**CARDINAL FREEMAN VILLAGE
137 Victoria Street, Ashfield**

**CONCEPT PLAN APPLICATION
MP 08_0245**

RESPONSE TO SUBMISSIONS REPORT

**Prepared for
Aevum Limited**

Revised Access Arrangements to Clissold Street

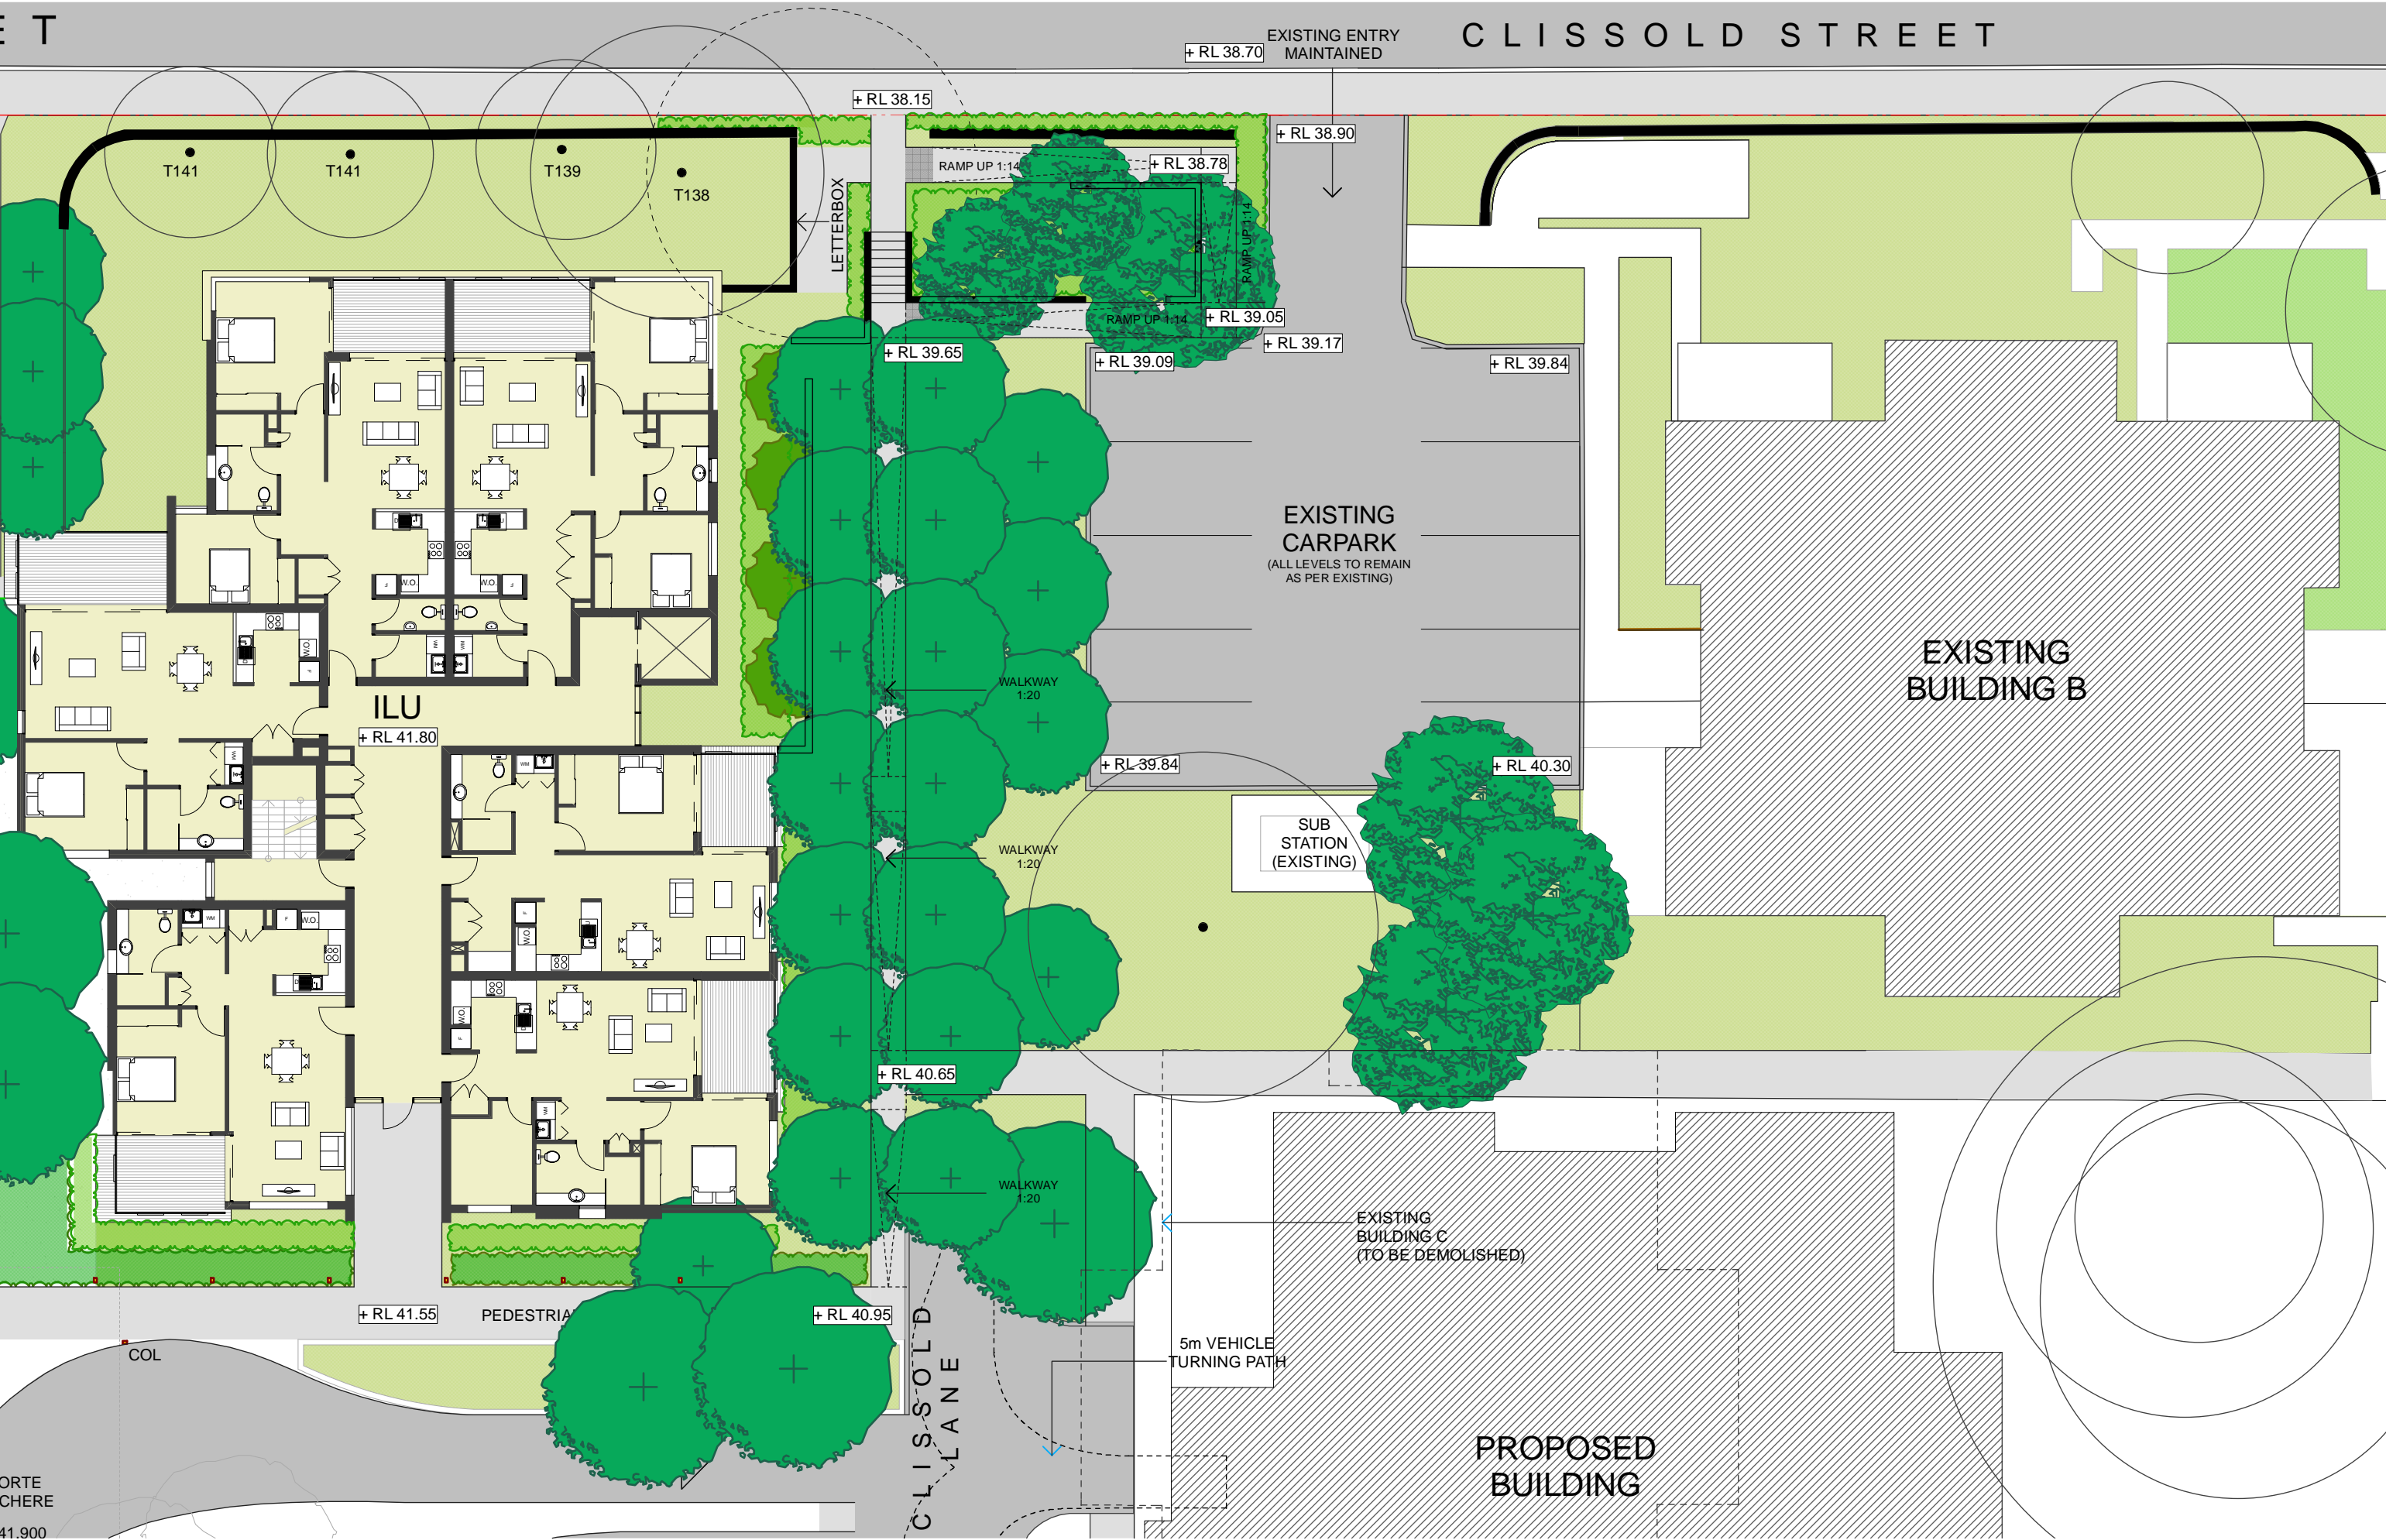
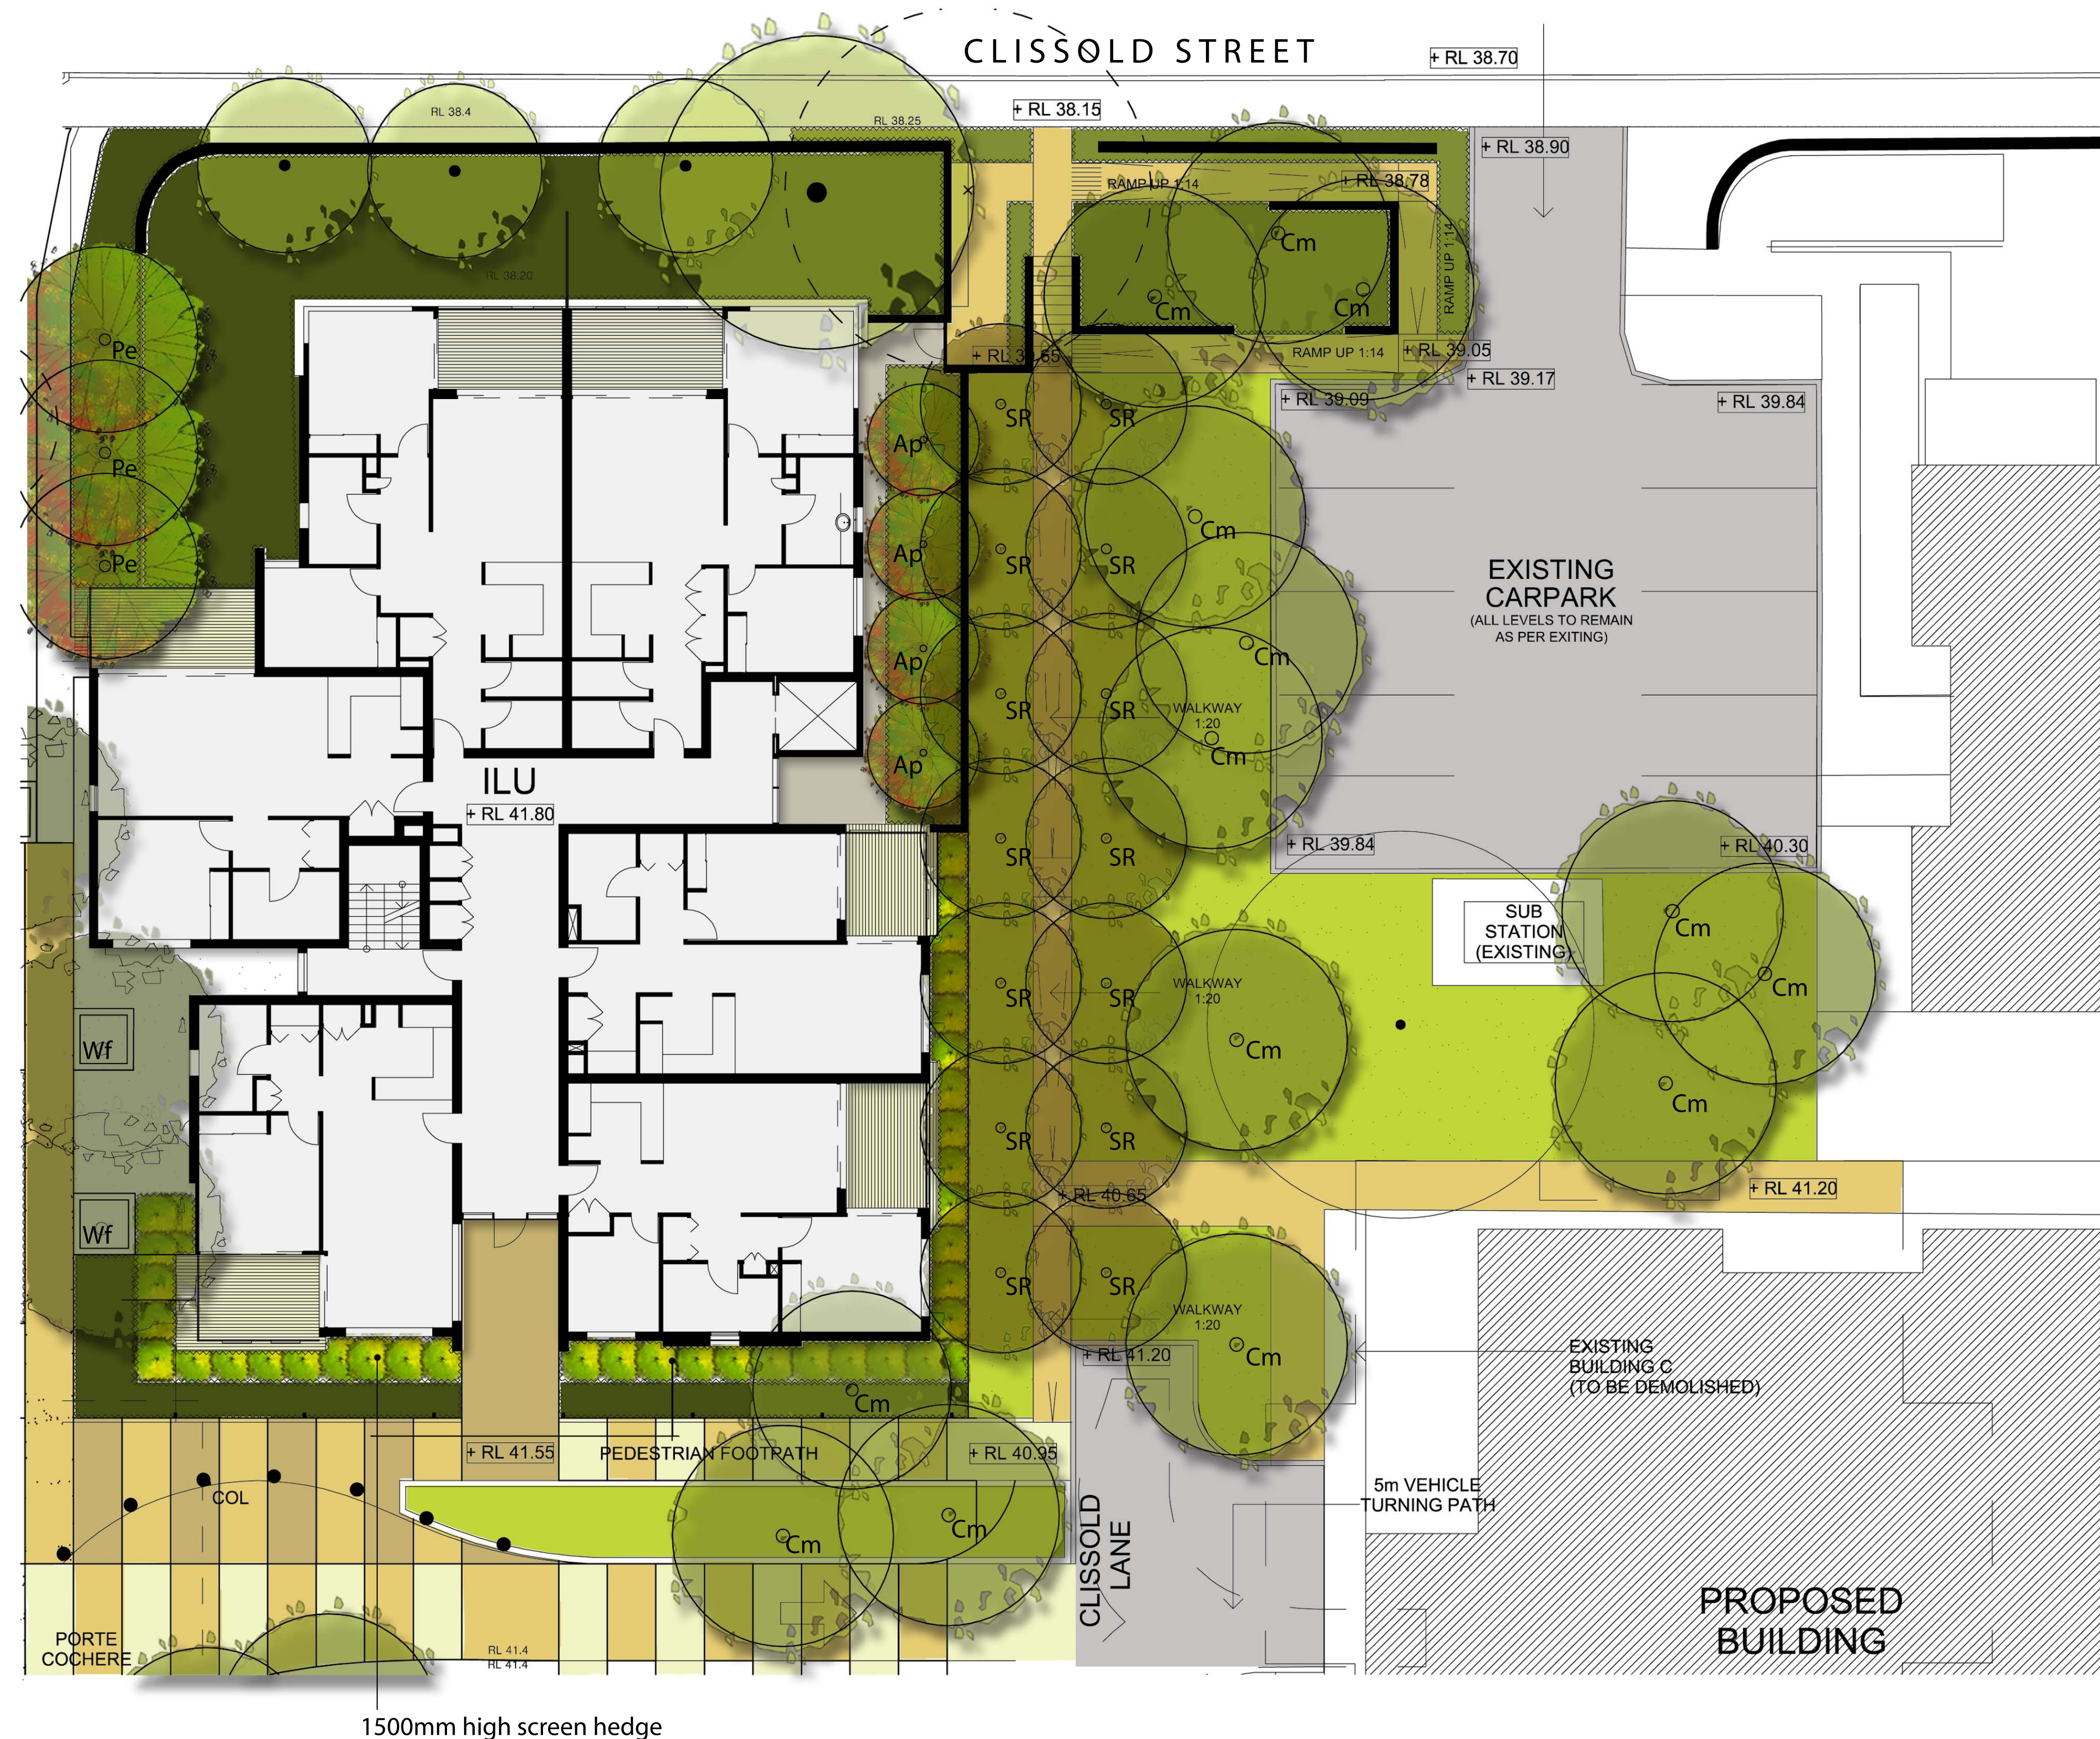
The access to the site off Clissold Street has been removed. Drawing SK01 prepared by Suturs Architects dated 21/07/10 shows a revised access arrangement with the removal of the Clissold Lane access (Appendix 5). Access to the basement of the RACF is retained off Clissold Street and separate access to the small carparking area is provided which is currently the case. This will retain access to car parking for existing residents.

The concept plan can be modified to reflect the access arrangements shown in Drawing SK01 Issue F contained in Appendix 5 and a condition of approval to the project application to this effect is invited.

Revised Drawing Chapel Lower Level (including heritage advice)

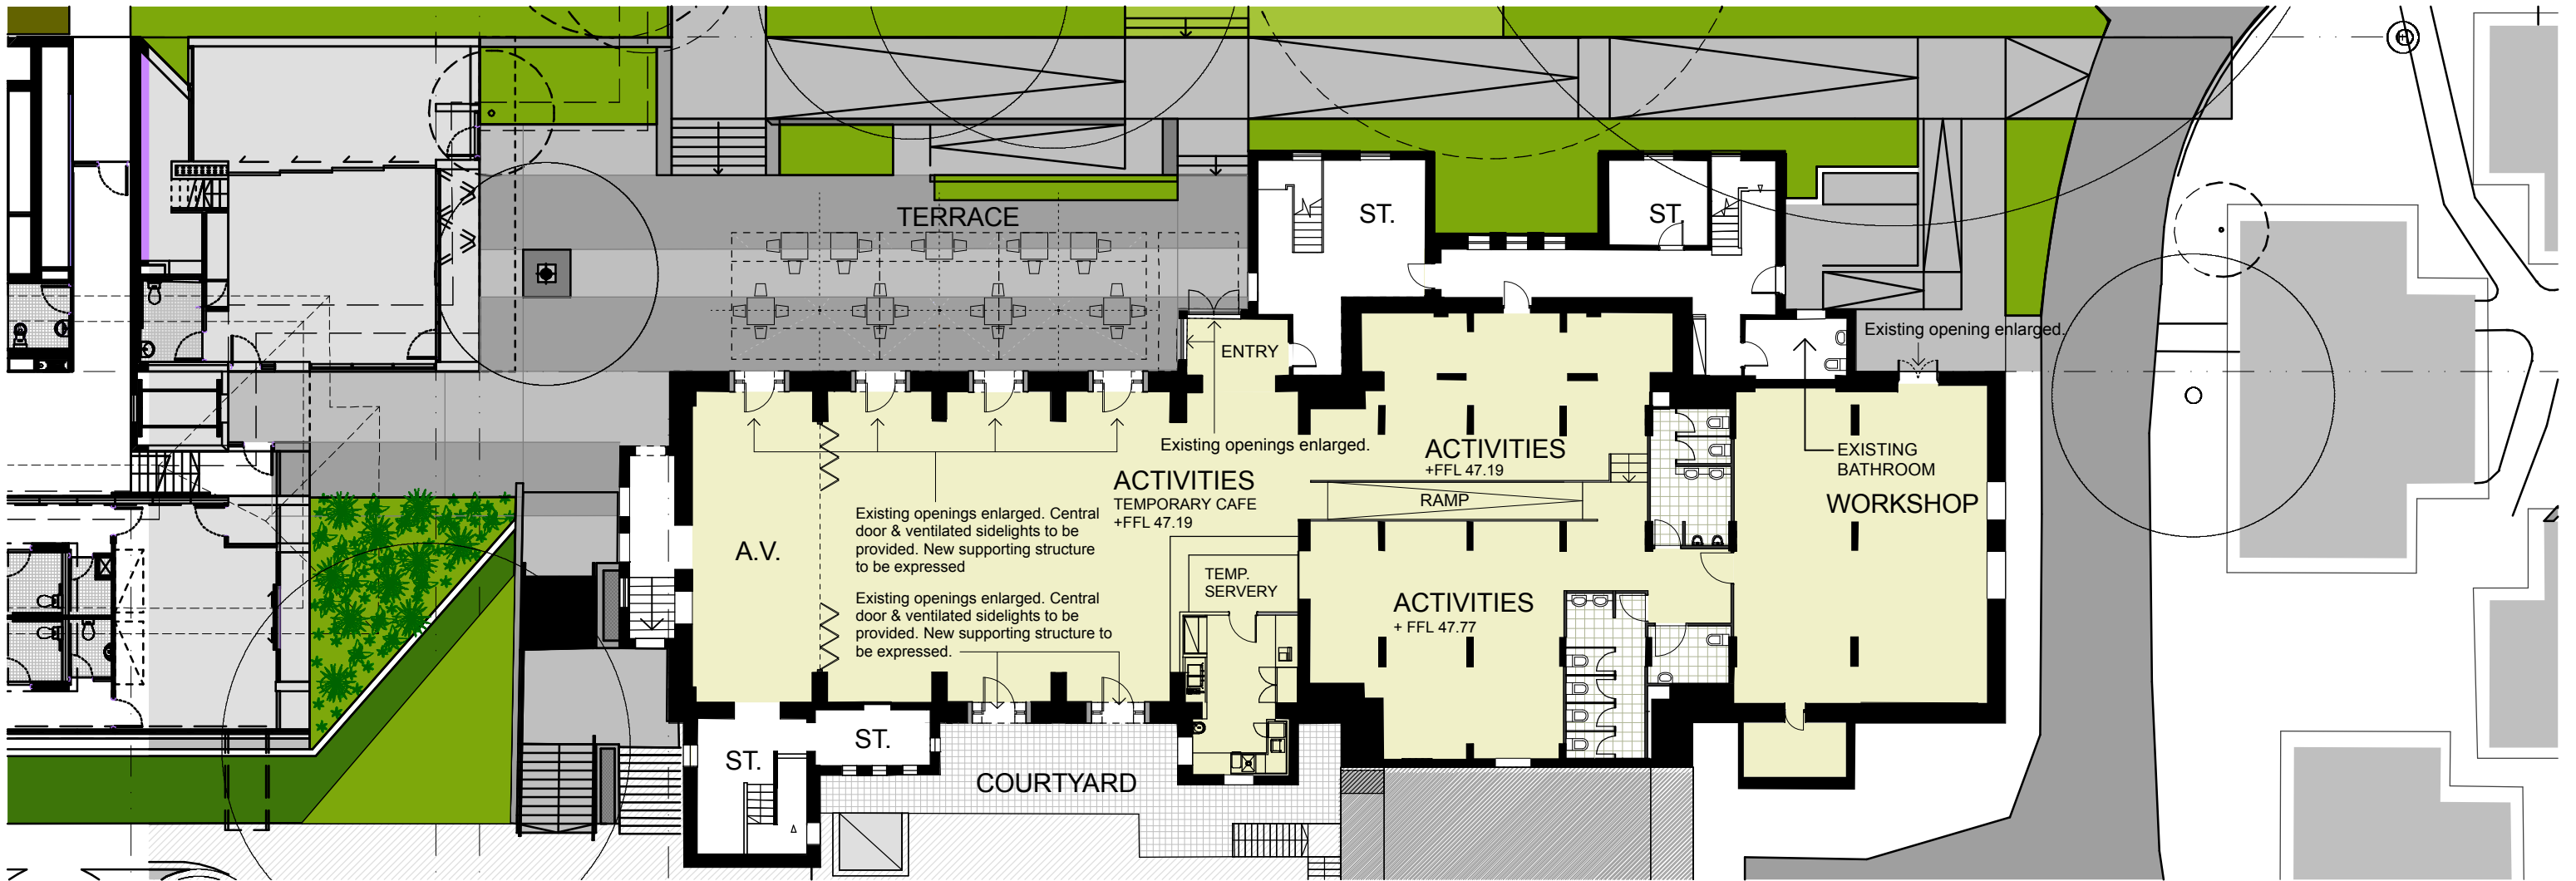
The lower ground floor of the chapel is located in the heart of the village with a large north facing terrace overlooking the new Village Green. A revised drawing has been prepared showing a more effective and function layout of this space providing approximately 300 square metres of high quality activity space for community events alongside a resident workshop space of 80 square metres (Drawing SK03 Issue E contained in Appendix 6).

The main activity space is dual aspect with both north and south facing windows providing opportunities for natural light, solar access and natural cross ventilation. The enlarged north facing windows will provide views to the outdoor seating terrace and Village Green beyond. The area has a generous floor to ceiling height of approximately 3.45 metres creating a sense of space and assisting in light penetration and ventilation.

Figure: The proposed design of the enlarged opening to the Chapel façade

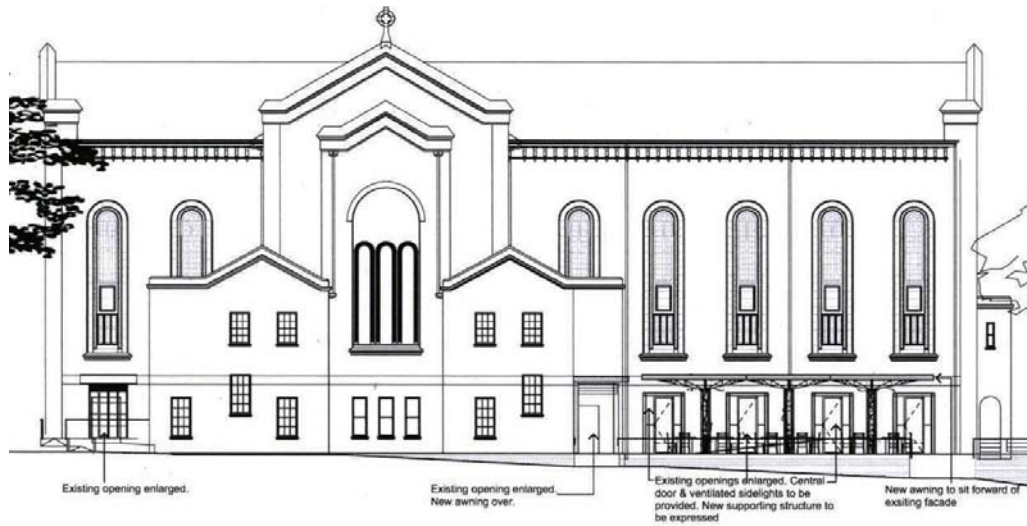
Graham Brooks and Associates supports the proposed amendment to design detail and recommends approval of the application.
